# **City of North Miami Beach, Florida**

## **CITY COMMISSION STAFF REPORT**

**TO:** Mayor and City Commission  
**THROUGH:** Esmond K. Scott, City Manager  
**Via:** Justin Proffitt, AICP, Community Development Director  
**FROM:** Sharon Cino, Planning & Zoning Manager  
**DATE:** September 24, 2020  
**RE:** Mixed Use Waterfront District (MU/EWF) and Mixed -Use (MU) District Zoning Code Text Amendments

**P&Z ITEM # 20-7 (MU/EWF) / (MU) Zoning Code Amendments for Intracoastal**

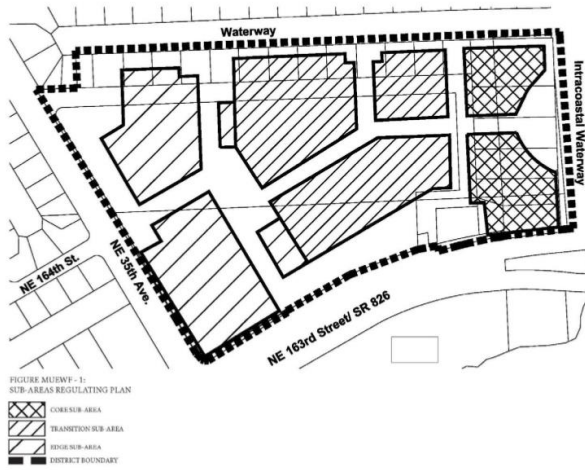
- **Floor/Story Heights.** The proposed changes in **Section 24-58 (R)(2)** are provided below:
  - a. Ground level stories shall be a maximum height of twenty (20) feet.
  - b. Second level stories shall be a maximum height of twenty (20) feet.
  - c. Each story above the second story shall be a maximum height of fourteen (14) feet.
  - d. Every building shall permit a single (1) specialty amenity story above the third story and above the fourteen (14) foot limit, for a maximum of twenty (20) feet.
  - e. For portions of interior spaces in buildings in mixed use districts that permit land uses that typically have higher story heights, such as movie theaters, auditoriums, television or other types of media studios, penthouse residential units, and similar land uses. The Community Development Director may waive the maximum story height.

The proposed change would incorporate special uses such as movie theaters and was recommended by Bermello and Ajamil to allow flexibility for unique amenities to be built such as movie theaters, auditoriums, media studios, and penthouse residential units. The proposed change will increase the maximum story height in a building from twelve (12) feet to fourteen (14) feet for added flexibility in building design and based on an evaluation of the existing mixed use ordinances. Additional height is recommended to allow for additional space for mechanical equipment as well. Each building will be allowed to have a unique amenity story built above the third story for a maximum of (20) feet. This change responds to multiple variances the city has approved for development projects featuring amenity decks with pools. The Second level retail requires higher floor heights to improve the quality of the development when two story retail is proposed in a project. These proposed changes are consistent with the recommended code changes in the upcoming Mixed-Use Phase II zoning code amendments.

- **Sub Areas Regulating Plan - Section 24-58.7(E) Figure MU/EFW 1.**

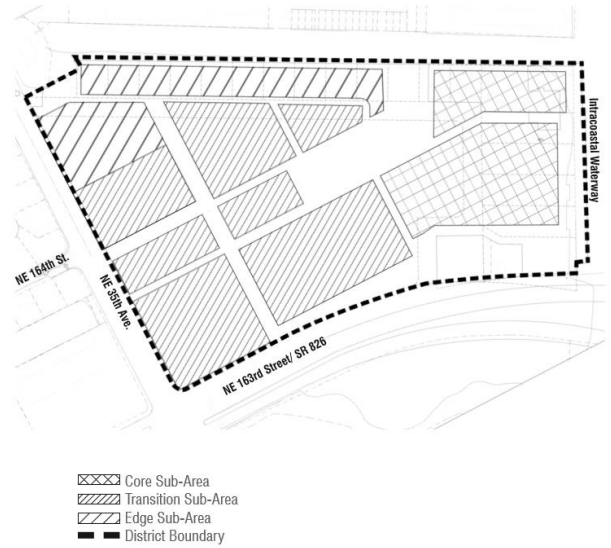
The diagrams below describe the previously adopted plan and proposed Core, Transition and Edge Sub Areas Regulating Plan: The proposed building height in the Core Sub-Area would be designated toward the waterfront, greenways and park vistas to promote a walkable neighborhood. These changes are requested in order to accommodate the conceptual master plan designed by the developer. As one regulating plan changes the others must be updated as well.

- **Street Network Connectivity Regulating Plan - Section 24-58.7(E) Figure MU/EWF 2**, the diagrams below describe the previously adopted plan and proposed plan.

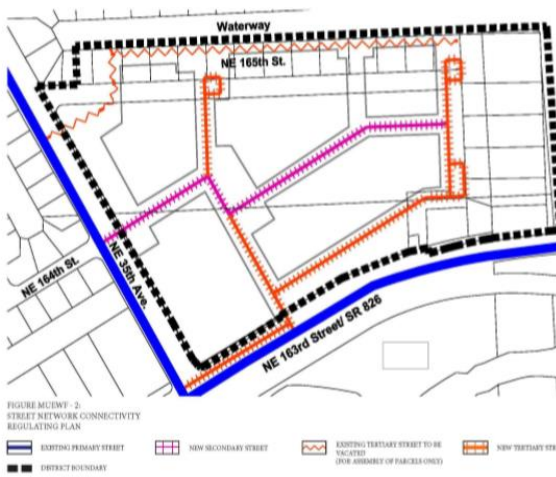
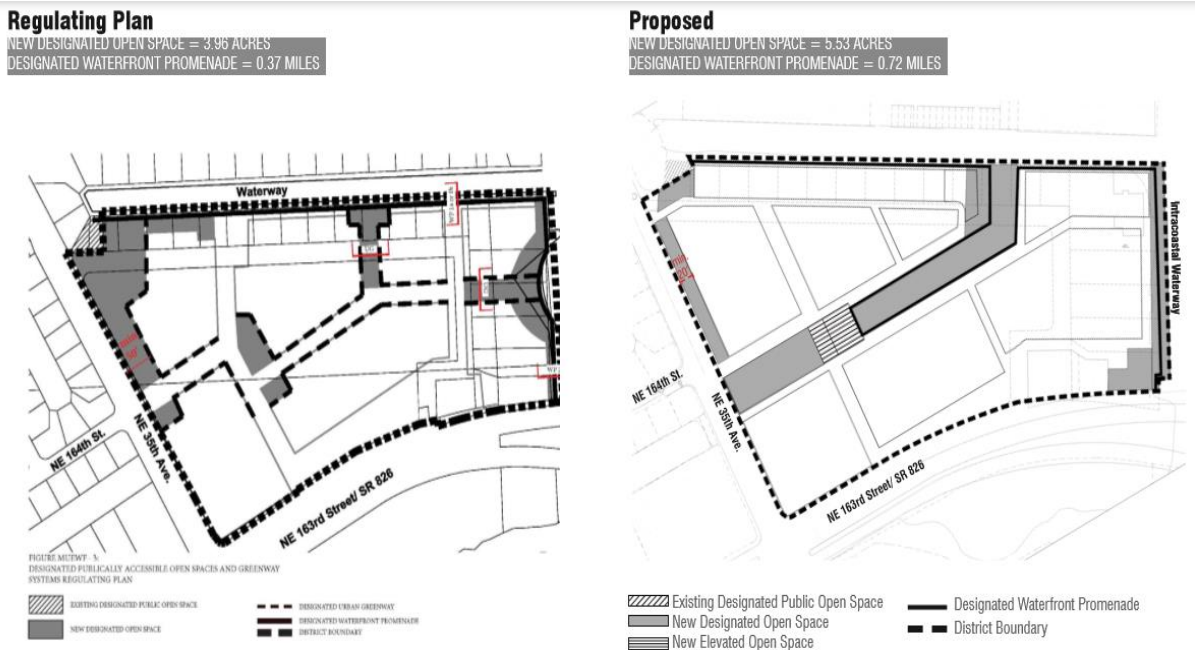
In the adopted plan, three streets are identified along NE 35 Avenue; a tertiary street at the northwest corner of the property, one at NE 164<sup>th</sup> Street, and a frontage road with a connection to SR 826 at NE 36 Avenue/Intracoastal Mall Driveway. In the proposed plan, three streets are identified at different locations along NE 35<sup>th</sup> Avenue: one at the northwest corner of the property; two at NE 164<sup>th</sup> Street (with the southern one of these being a one way eastbound only). In both plans, the direct east and west access to and from SR 826 is shown as NE 36

Avenue/Intracoastal Mall Driveway. The proposed development will also include a signal at the intersection of SR 826 and NE 36 Avenue/Intracoastal Mall Driveway. The requirement in Section 24-58.7(O)(2)(e) states that street network connections associated with the proposed development shall not overburden NE 35 Avenue and shall provide multiple access points providing direct east and west access to and from 826/NE 163<sup>rd</sup> Street.

- **Building Heights Regulating Plan & Maximum Permitted Height – Sections 24-58.7(E) and (J) Figure MU/EWF-4 and Table MU/EWF-2:** The diagrams below describe the previously adopted plan and proposed.

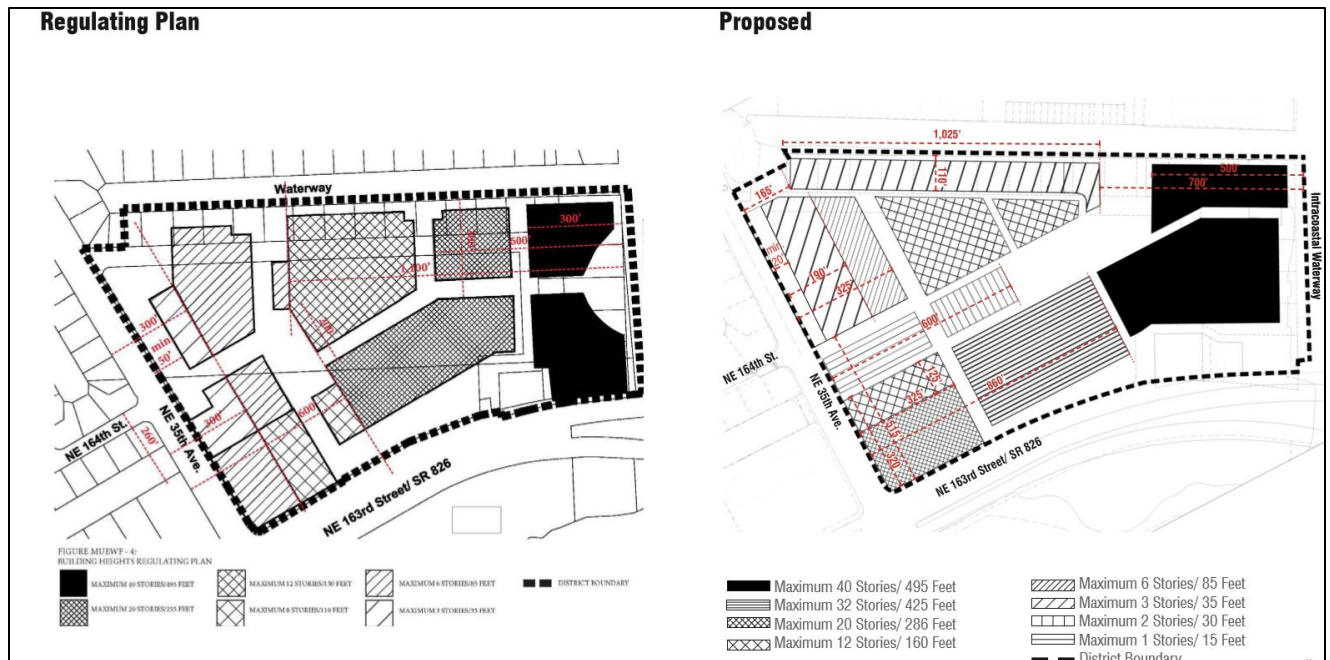
The proposed change redistributes the building heights in the MU/EWF district. The applicant states that redistributing the building heights is necessary:

Below is a graphic from Sheet A1-15 of the Master Concept Development Plan. The left side of the graphic shows the current Building Heights Regulating Plan adopted by the City Commission in 2015. The right side shows the proposed regulating plan. The main difference between the two regulating plans is the general redistribution of the building heights and massing from the northern side of the district to the southern side of the district. In the adopted plan, the building heights increase from west to east starting with 3 stories along NE 35<sup>th</sup> Avenue and ending with the Core Sub-Area (Dark Black) at 40 Stories along the intracoastal waterway. The proposed plan redistributes building height by increasing from the north/northwest to the southern side of the district and property line along NE 163<sup>rd</sup> Street.

Table MU/EWF-2 below provides a summary of the heights per sub-area. The proposed changes to Table MU/EWF-2 reflect the redistribution of heights in the Building Heights Regulating Plan and further define the third note in the table. The third note in the table permits flexibility in the number stories in a building as long it does not exceed the overall height maximum measured in feet. Developers must demonstrate that although the building has more stories than what the code permits, the resulting density and intensity does not exceed the density and intensity that would otherwise be accommodated in the maximum number of stories permitted. Adding the word “density” clarifies that even if the building has more stories than the maximum permitted, the same number of residential units exist in the building. Currently, the code does not define how many additional stories can be requested by a developer. City staff recommend capping the number of stories that can be requested under this provision.

Additional staff discussions were held with the applicant to include additional building height limitations to the proposed building height regulating plan. Specifically, building heights at the intersection of 163<sup>rd</sup> Street and NE 35<sup>th</sup> Avenue would transition from a maximum height of 20 stories and then stepdown to a maximum height of 12 stories, then a maximum height of 1 story for the park/open space. The proposed building heights along the park area on the east side of 36<sup>th</sup> Avenue would transition to a maximum height of 3 stories. Both of these park/open space areas would be limited to buildings associated with recreation only. The proposed building heights near the north property line along the waterfront would be limited to 3 stories instead of the 12 stories shown on the applicant's plan. City staff is recommending this change to allow a transition of building heights to occur given the proximity to the adjacent residential neighborhood and to concentrate building heights generally to the south.

- **Ground Floor Active Use Requirement for NE 35<sup>th</sup> Avenue South of NE 164<sup>th</sup> Street.** The proposed changes in **Section 24-58-7 (G)(1)(e)** are provided below:

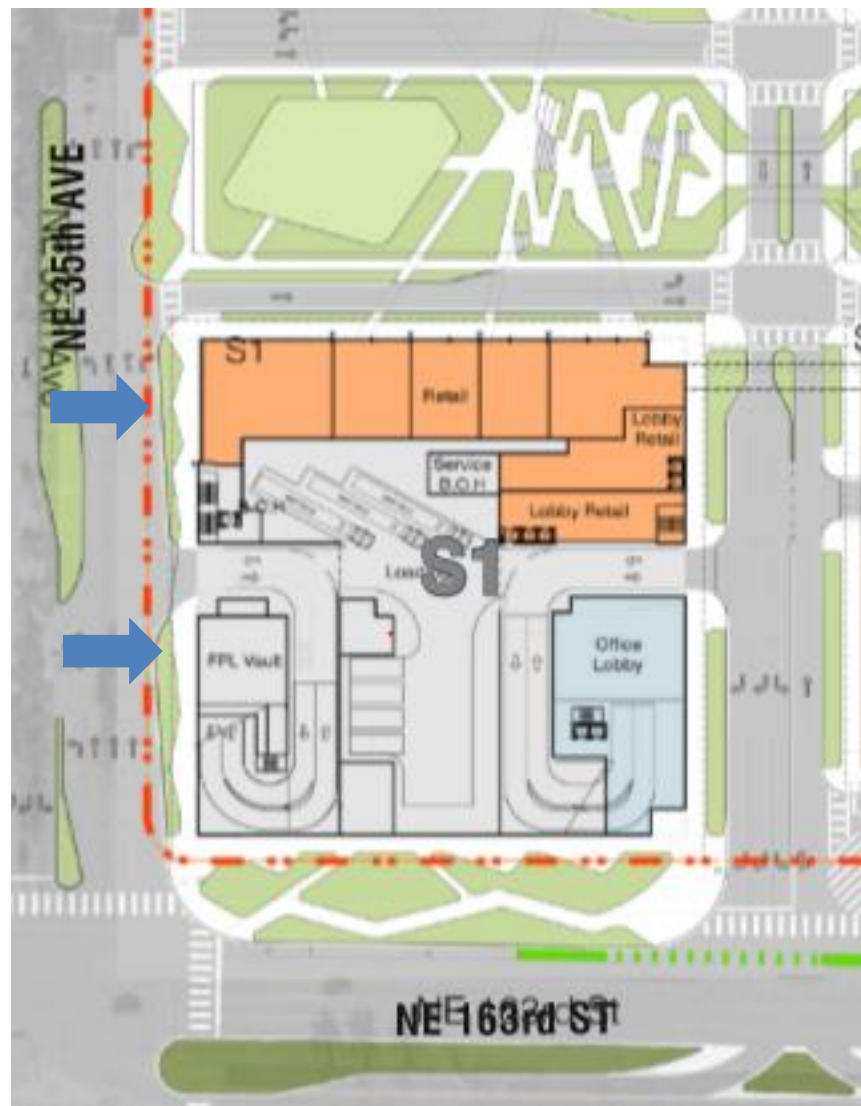
*Buildings fronting NE 35th Avenue, south of NE 164th Street, shall contain active use for a minimum of twenty-five (25%) of the building frontage along the ground floor only fronting NE 35th Avenue.*

The proposed change is necessary for the proposed building on Sheet A1-16 of the conceptual master plan to accommodate the entrance to the parking garage and interior service areas.

25% building ground floor frontage to include retail storefronts

Rest of ground floor façade devoted to parking garage structure, driveway to interior space with architectural screening.

- **Development Adjacent to NE 35th Avenue..** The proposed changes in **Section 24-58-7 (G) (1) (i)** and **Section 24-58-7 (G) (1) (h)** are provided below:

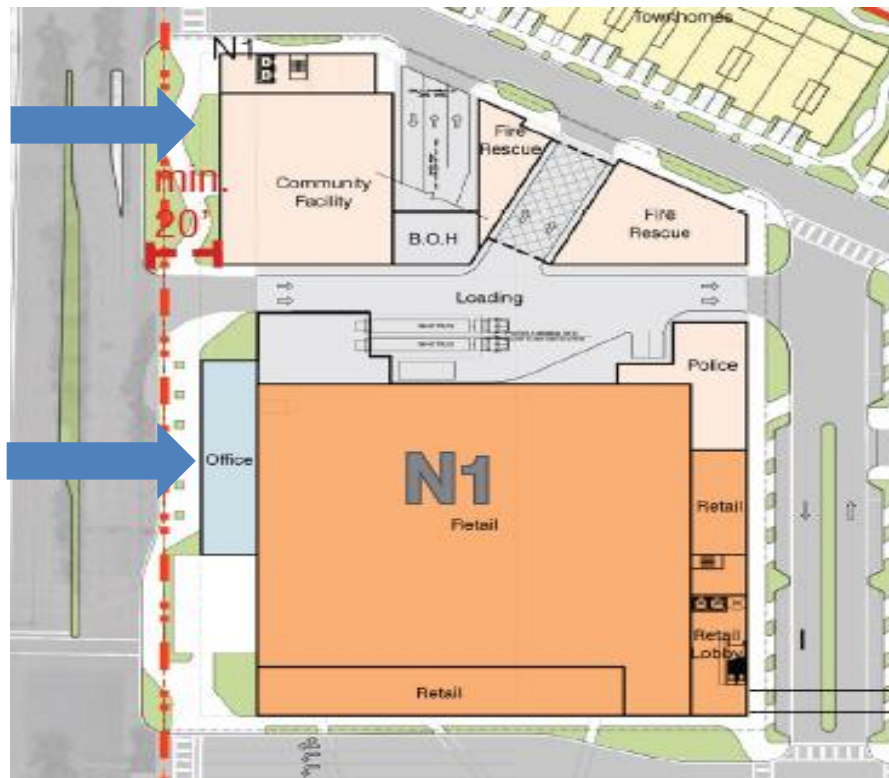
*i. Create a fifty-foot-wide landscaped buffer within the proposed project property along the property line, between the proposed development and that portion of NE 35th Avenue as specified in the Designated ~~Publically~~ Publicly Accessible Open Space and Greenways Systems Regulating Plan Figure MU/EFW-3. The landscaped buffer shall not contain any structures, ~~driveways, or roads~~, except connecting driveways or roads to the development, liner buildings, sidewalks, bike paths, transit shelters or similar;*

The proposed change would permit connecting driveways or roads into the development and liner buildings within the fifty foot landscape buffer area along NE 35<sup>th</sup> Avenue. The developer’s concept master development plan shows a one way parking garage entrance for access to the retail/tenant service bay, new fire station with two fire truck spaces, and a police substation. All of these facilities would be interior to building N1 on sheet A1-16 of the concept master development plan. There is also a proposed two way street into the project north of building N1 to provide traffic circulation in and around the site. To screen building N1’s parking garage with occupiable space rather than typical parking garage screening materials, this change also proposes to permit a liner building along the parking garage façade. In the mixed use zoning, liner buildings screening parking garage spaces are preferred over the typical metal/landscape wall screening devices. They soften the views of buildings and create a better pedestrian environment from the sidewalk. The developer shows that this space would be used for the community center facility and office uses no higher than three stories.
